Pacific Sardine Stock Assessment Review Panel Meeting Report

NOAA / Southwest Fisheries Science Center
La Jolla, California
February 24-27, 2020

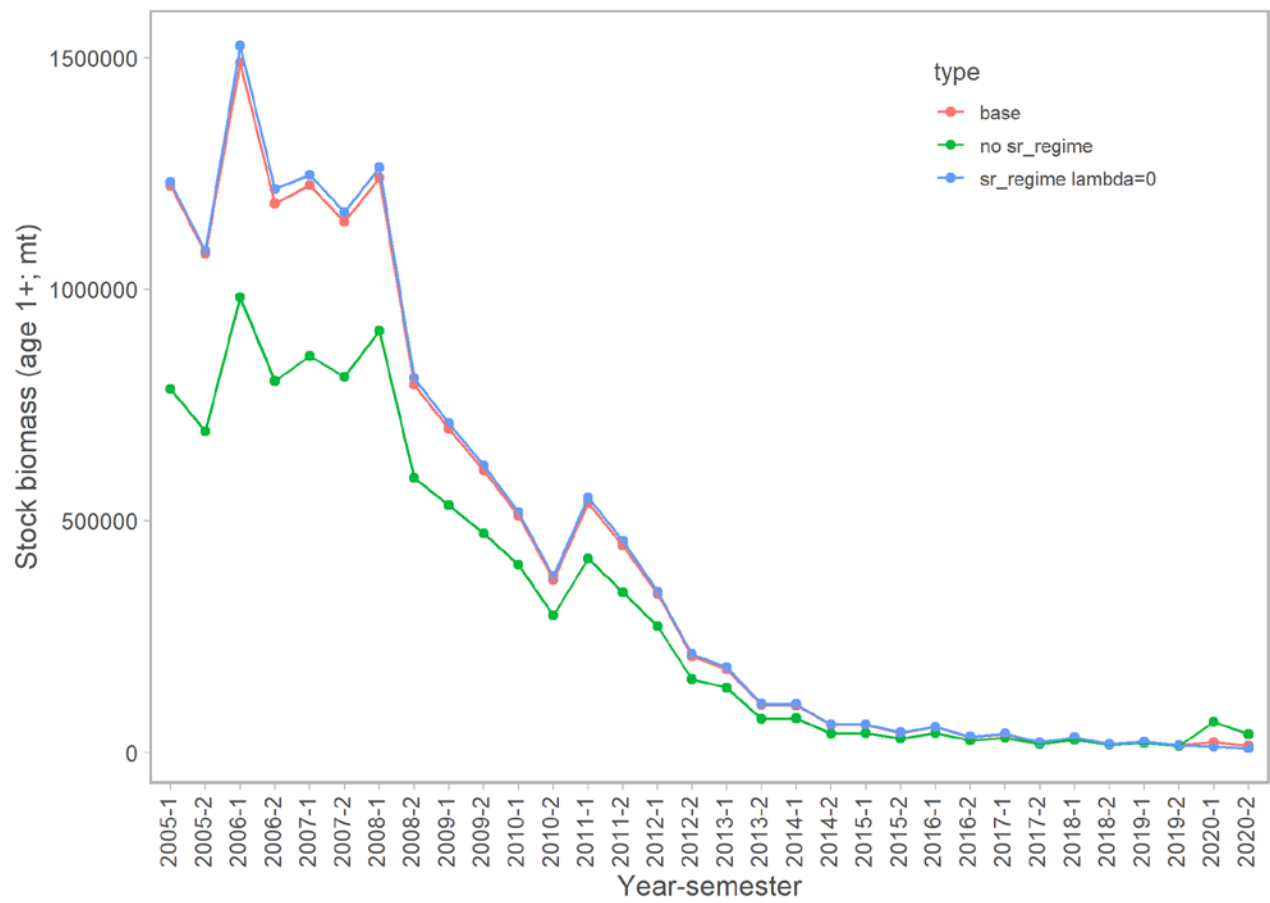
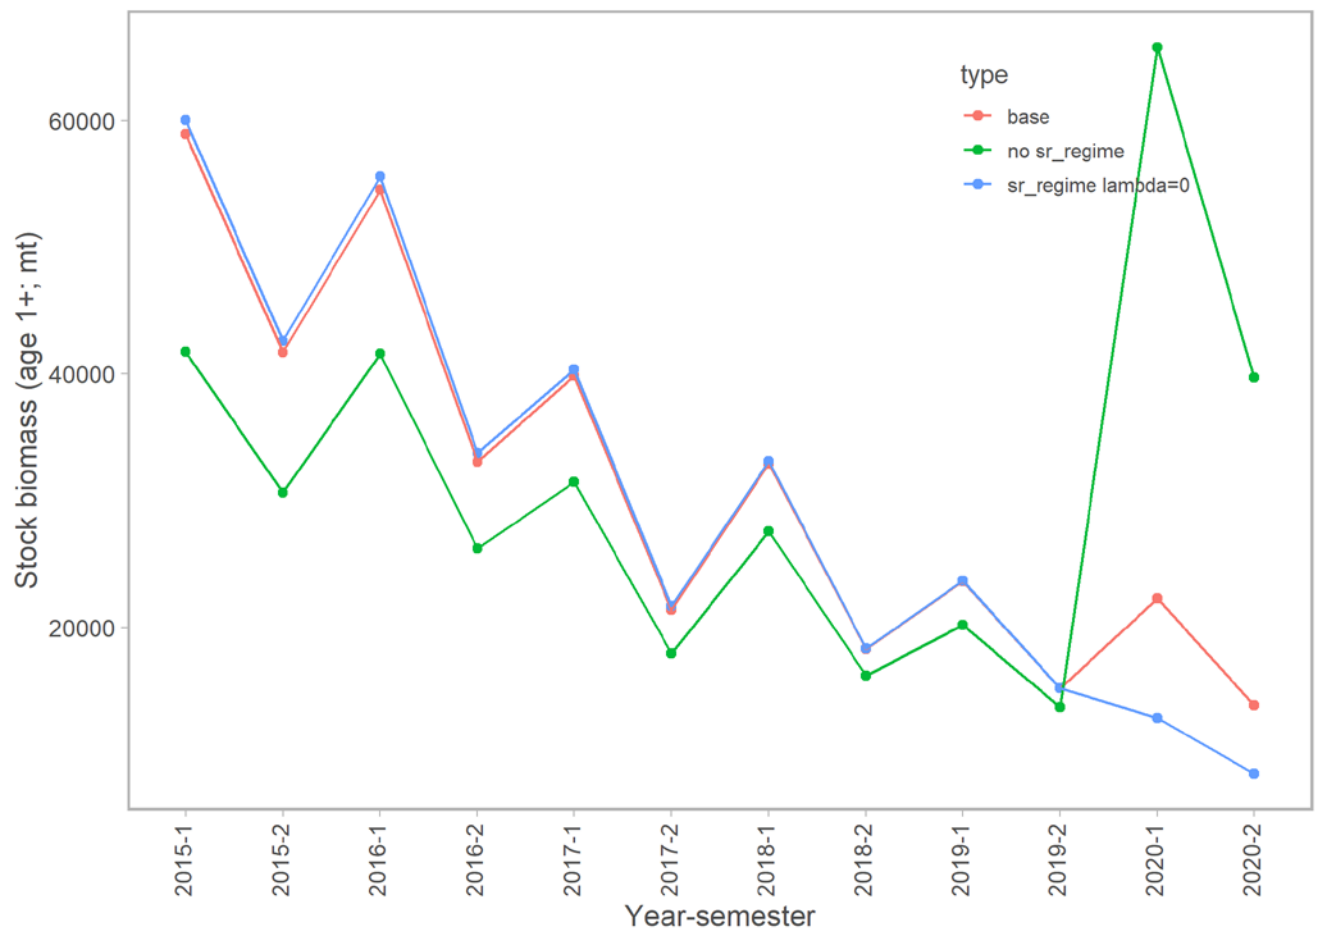
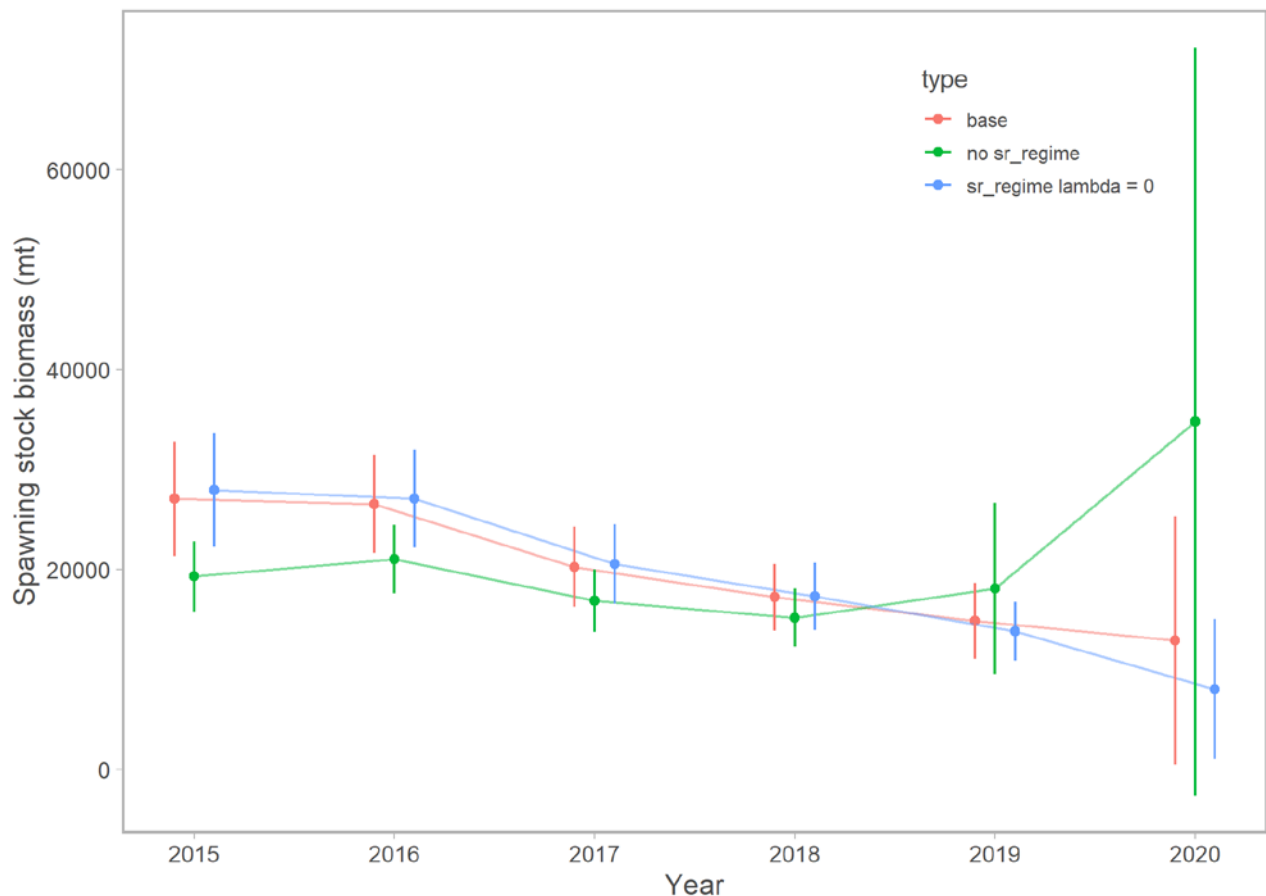
Request 14: Run a model without the R1 offset and with the R1 offset estimated but with no penalty on this parameter.

Rationale: The Q profile has a likelihood component for the R1 offset (aka the “SR regime parameter”), but it was never the intention to impose a penalty / prior on this parameter – the STAT and Panel were unclear how this penalty was defined.

Response: The 2005-2020 stock biomass is shown below. The three lines are the 2020 proposed base model (“base”), a model does not estimate the SR regime block parameter (“no sr_regime”), and a model with the SR regime parameter assigned a lambda of 0 in the likelihood (“sr_regime lambda=0”). It was agreed that setting the lambda for the R1 offset to 0 is the best approach because it best matches the intent of how this parameter was to be treated in the 2017-2019 assessments.

Below is a plot of the previous figure zoomed in to focus on values from 2015-2020.

The figure below is zoomed in to focus on spawning stock biomass values from 2015-2020. The bars indicate the uncertainties (mean +/- standard deviation) associated with the point estimates of spawning stock biomass.

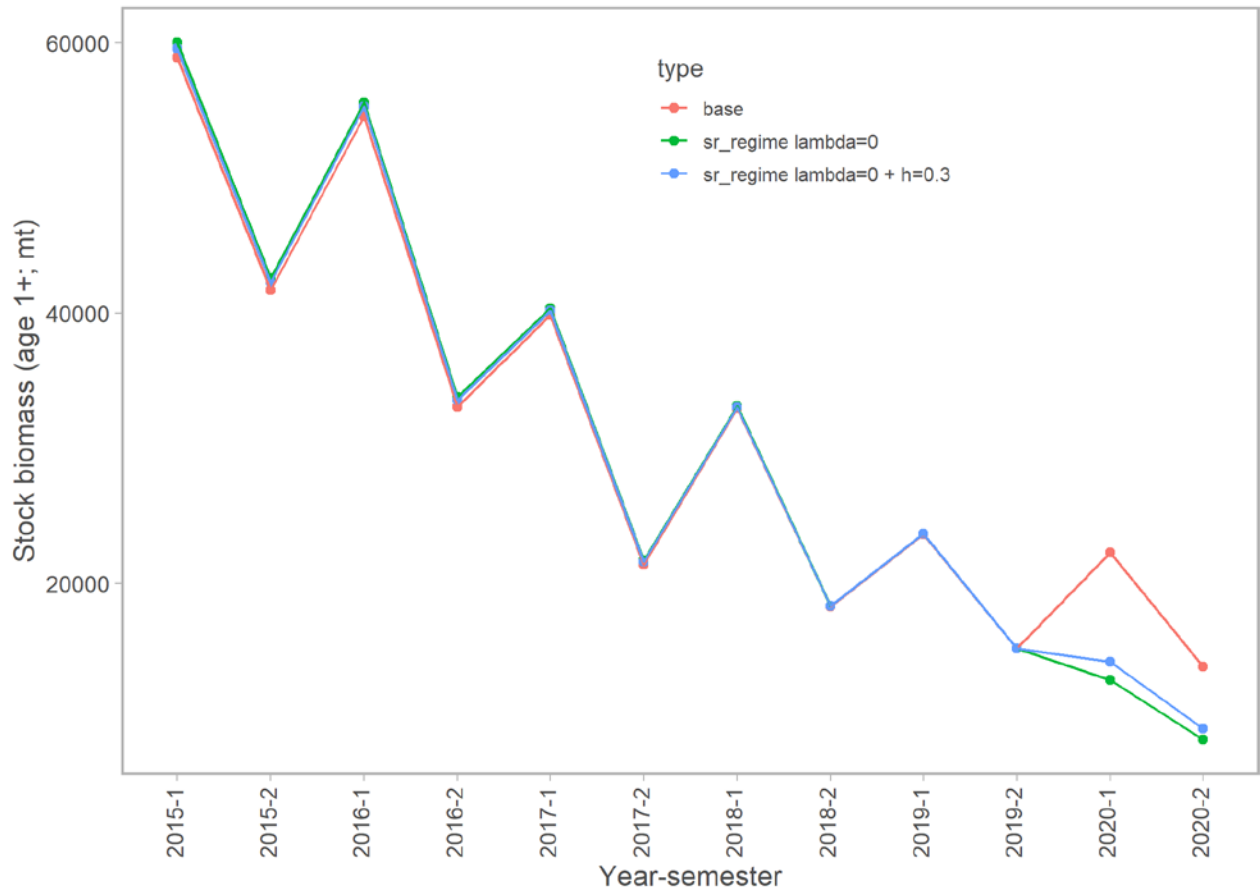
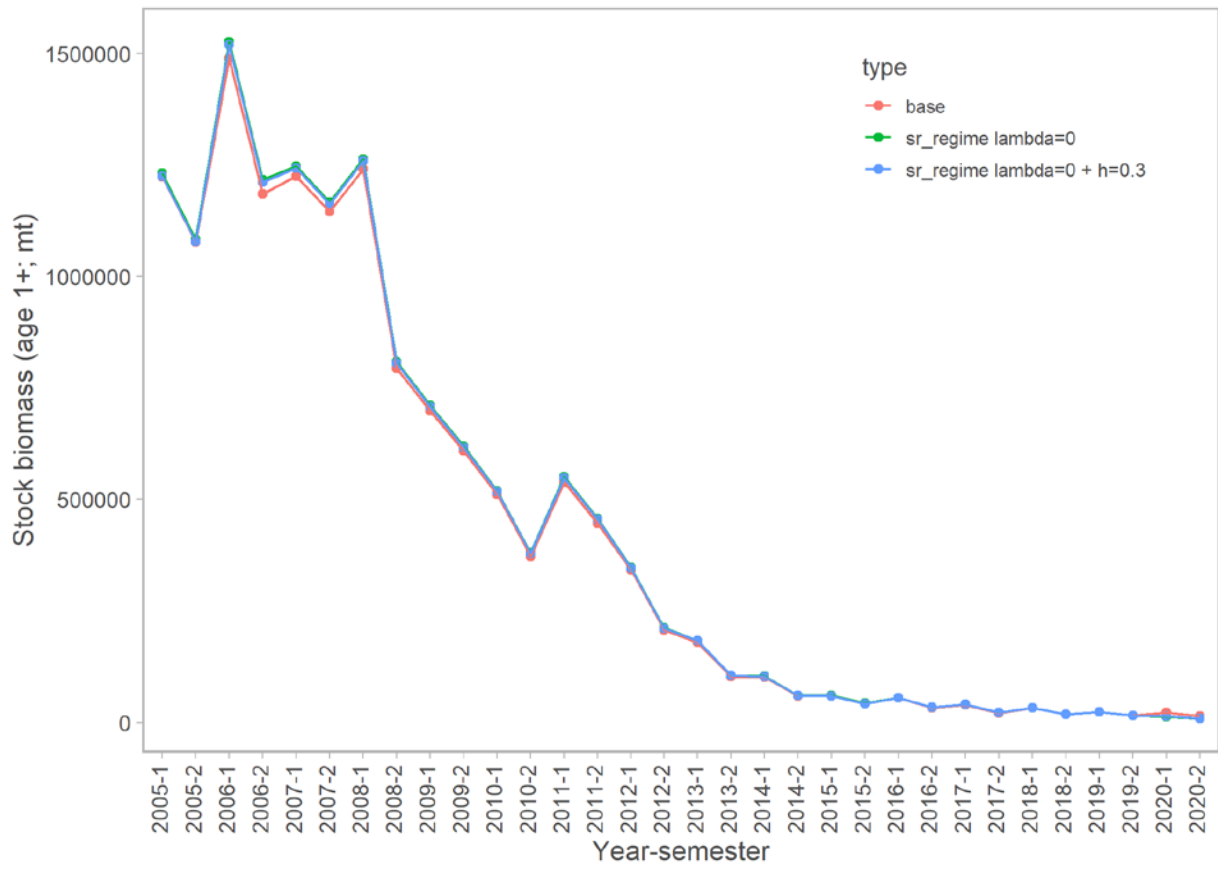
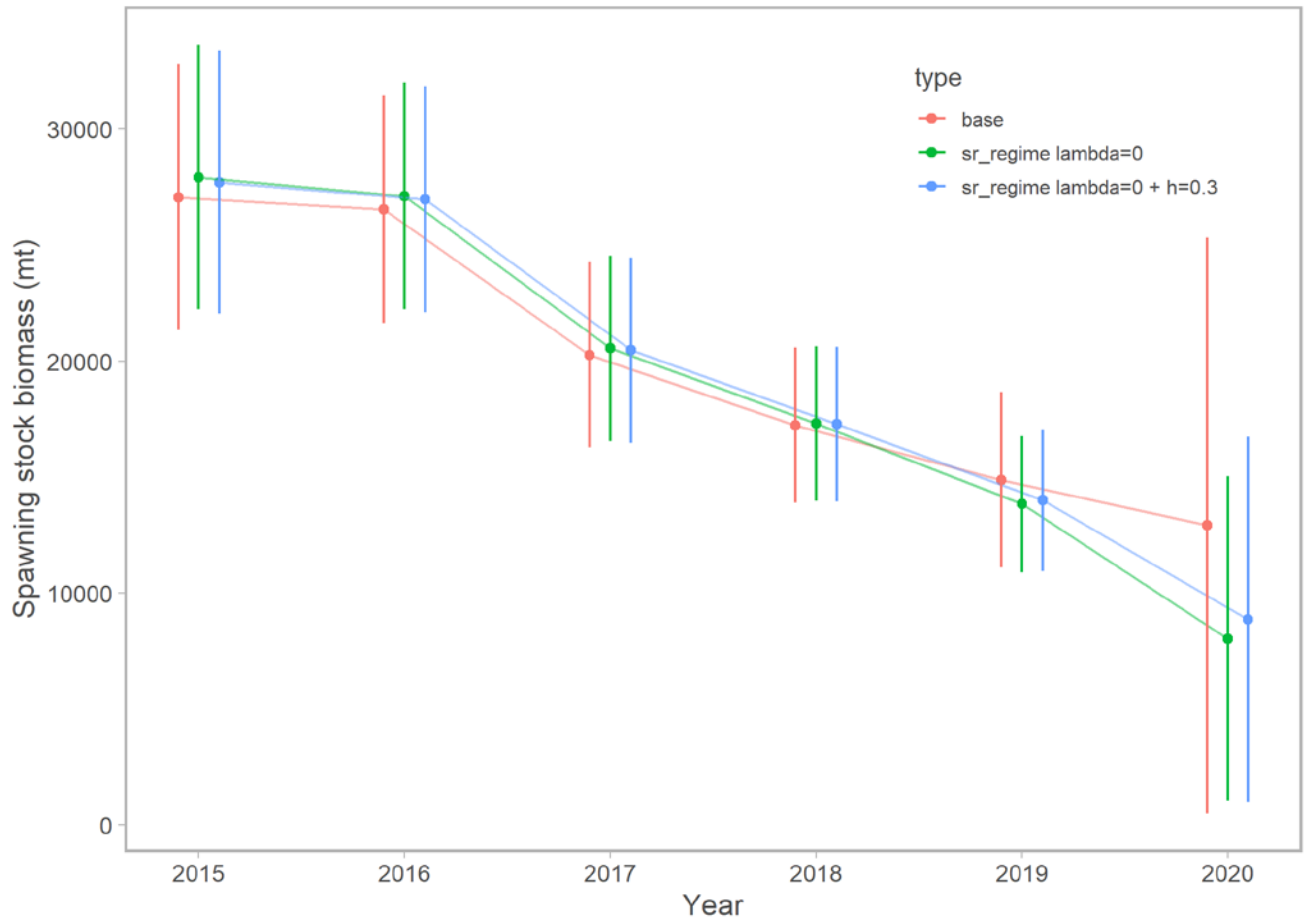
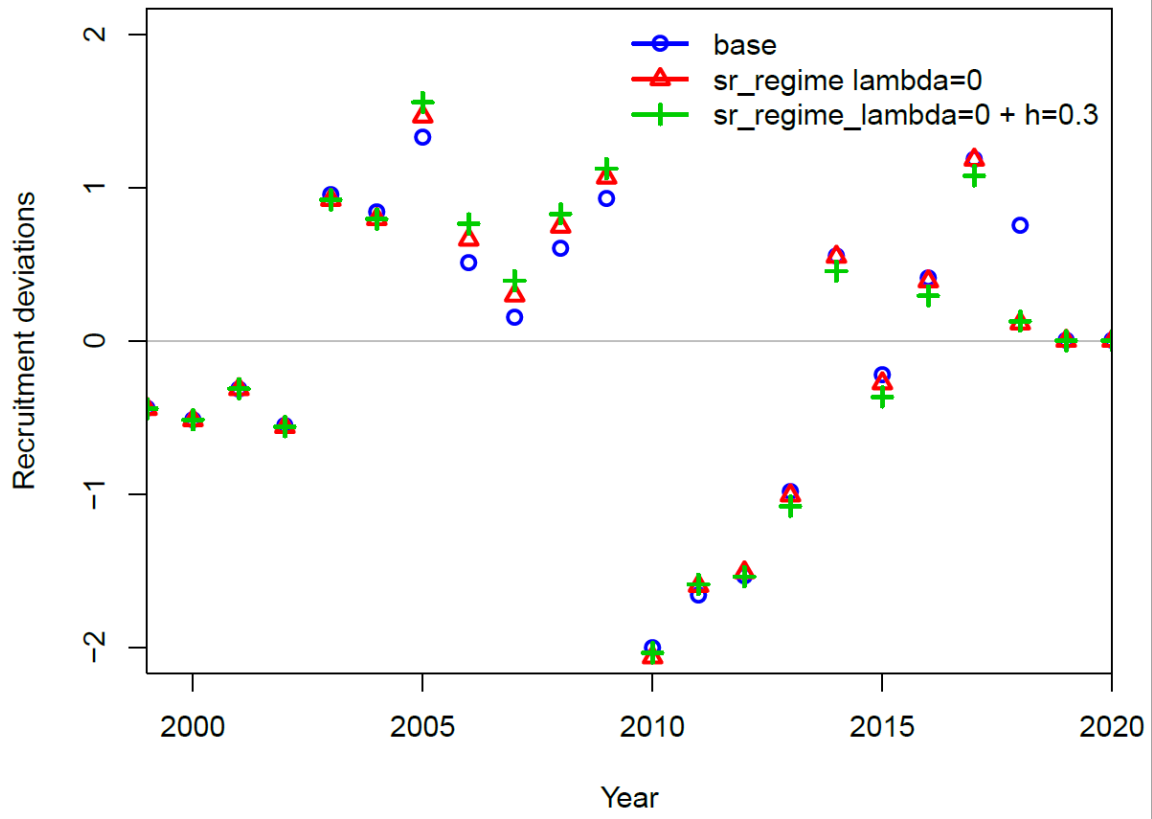
Request 16: Evaluate whether the model without the R1 offset (see Request 14) can estimate steepness. If not, conduct a model run with steepness fixed at 0.3.

Rationale: It is not clear which data are informing the estimate of steepness; the current base model appears to depend much on the R1 offset.

Response: Steepness was not estimable, and the STAT proposed to set steepness at 0.3 (a value consistent with previous estimates). The three figures below show the 1+ biomass time series for 2005-2020 and 2015-2020, and the recruitment deviations. The STAT and Panel agreed that steepness would be fixed at 0.3 in the final base model.

The figure above shows the recent time series of spawning stock biomass and the values +/- the standard deviations.

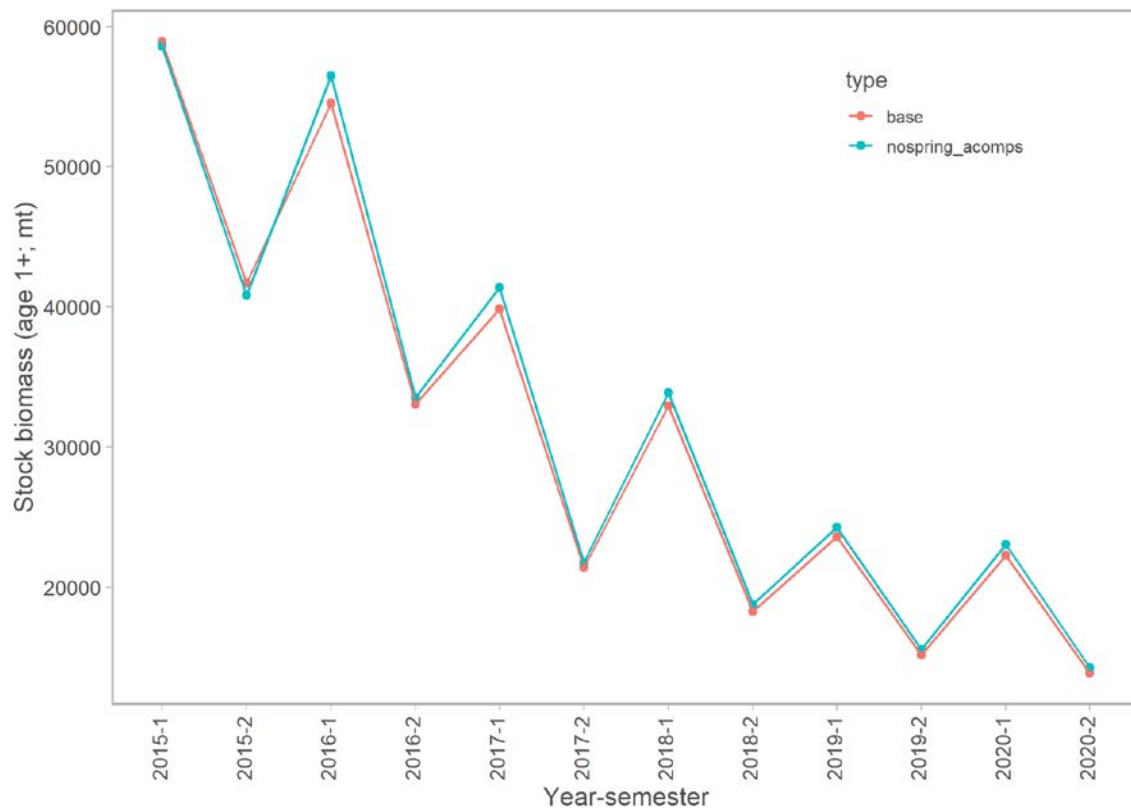
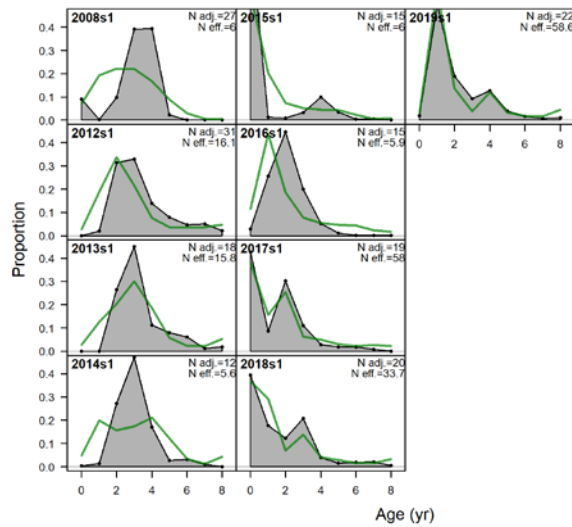
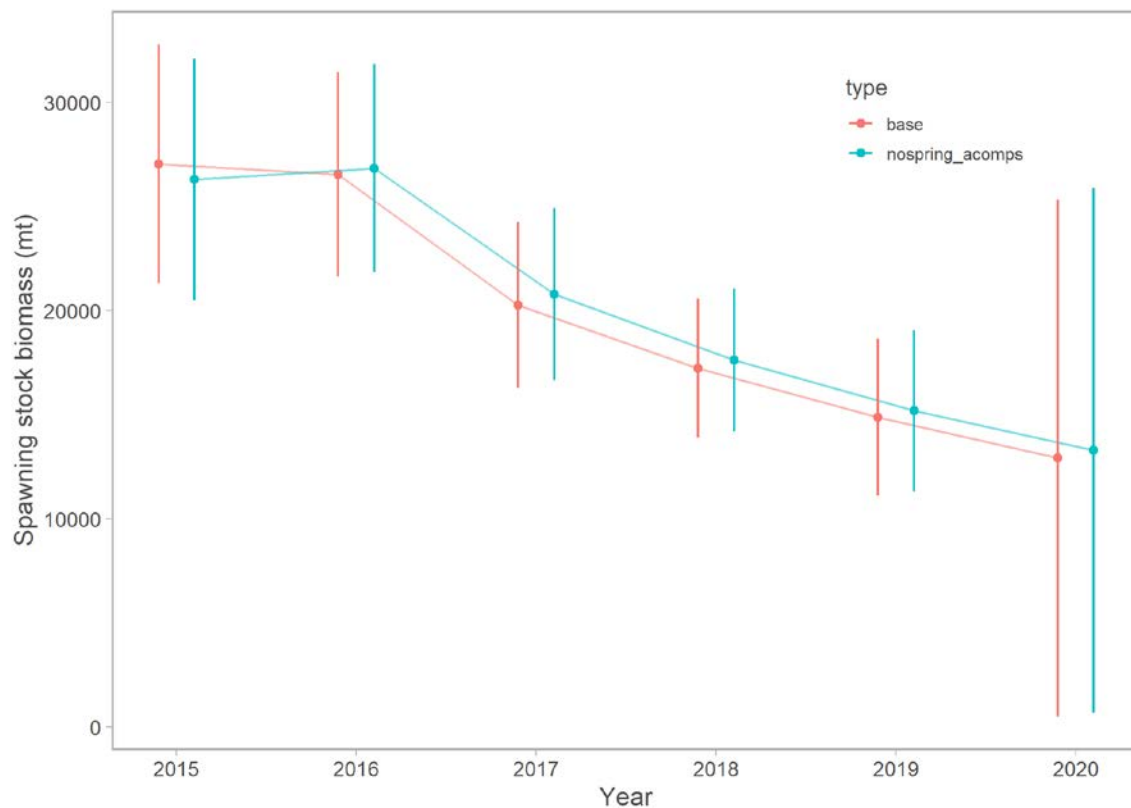
Request 17: Examine the sensitivity to removing the spring AT age data.

Rationale: The spring AT age data are based on a pooled age-length key, which is not appropriate because the estimates of age-frequency will be biased as no account is taken of varying cohort strengths.

Response: The fits to age compositions in which fish were re-aged (2017 and 2018) and 2019 were relatively good. The STAT and Panel agreed that the spring AT age data would be excluded from the final base model.
